SMITH SUBDIVISION, NO. ONE

APPLICATION NUMBER 22 DATE July 15, 2004

REQUEST Subdivision

DETAIL SITE PLAN

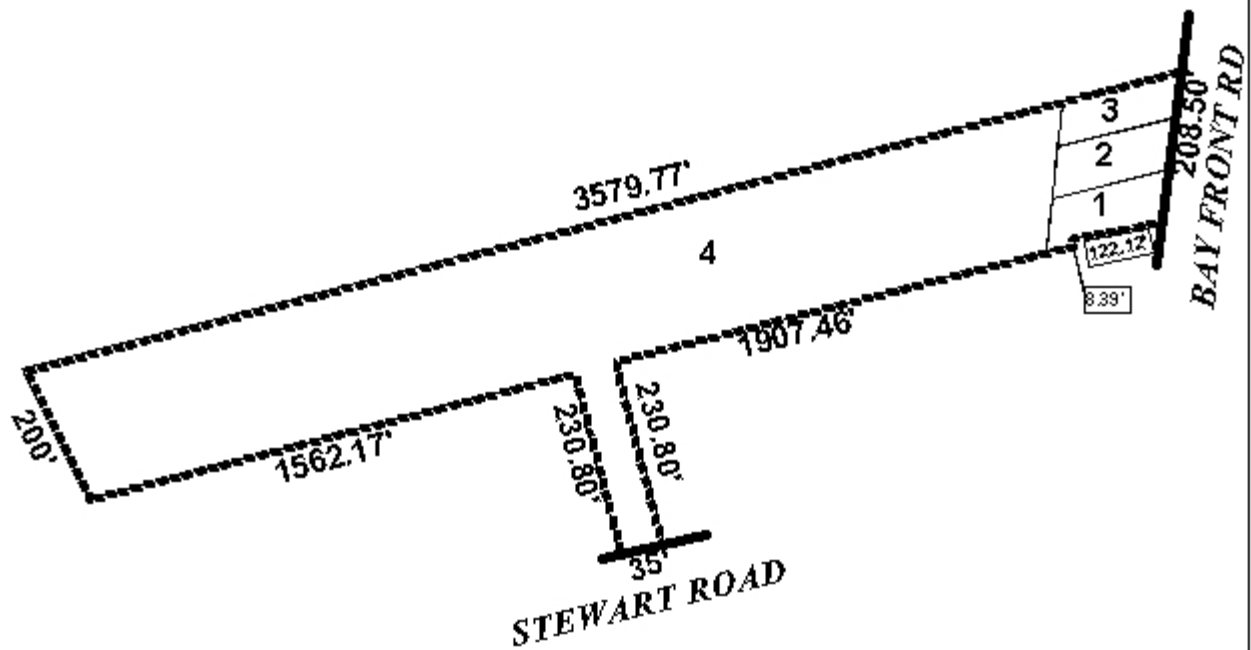
Lot 4 exceeds the maximum width to depth ratio as recommended by the Subdivision Regulations; therefore, a waiver of Section V.D.3. would be required. However, narrow, deep lots are common in this area; thus the waiver of V.D.3. would be appropriate.

As proposed, Lot 4 has only 35-feet on a public road, thus a note should be placed on the final plat stating that there can be no future resubdivision of Lot 4 until additional frontage is provided on an open and maintained public right-of-way.

The plat does not illustrate the balance of the property to the West of Lot 4. Tax Assessor information illustrates that the parcel to the West is owned by the same person and the parcel numbers illustrate this was all one parcel. Furthermore, it appears that subdivision of this site would land-lock the parcel to the West. The balance of the parcel should be included in the subdivision or the submission of documentation to establish the parcel as a legal lot of record prior to 1952, should be required.

Based upon the preceding, this application is recommended for holdover to allow the applicant to include the balance of the property in the subdivision, with additional notification information; or the submission of documentation to establish the balance of the property as a legal lot of record prior to 1952. This information should be submitted by July 19th to be considered at the Commission's August 5th meeting.
